Exhaust Manifold Bolts - Sport Jet 120

MODELS AFFECTED:

1995 Sport Jet 120
S/N 0E093700 thru 0E125508

Figure 1

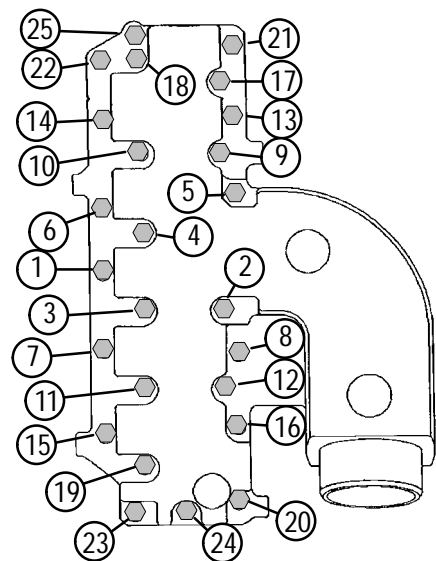
We are receiving sporadic reports from the field on Sport Jet 120's that have leaked water at cylinder and exhaust manifold parting line.

Investigation of this problem revealed reduced (low) clamp load on exhaust manifold gasket. This is caused by initial thermocycling of powerhead which reduced torque of stainless steel bolts.

Engineering has recognized this as an area which needed improvement and developed a new bolt. This bolt has capacity for higher torque and significantly increased clamp loads.

NOTE: It is very important to oil bolt threads and underside of head prior to installation to achieve proper and uniform clamp load.

1. Remove bolt #1 per Figure 1. Install new bolt and existing washer. Torque bolt to 115 lb/in (13.0 N-m). Then, follow same procedure for bolt #2 and so on until all bolts have been replaced and torqued following the sequence in Figure 1.

2. After all bolts have been replaced and torqued, retorque bolts #1 thru #8 (center bolts) per Figure 1.
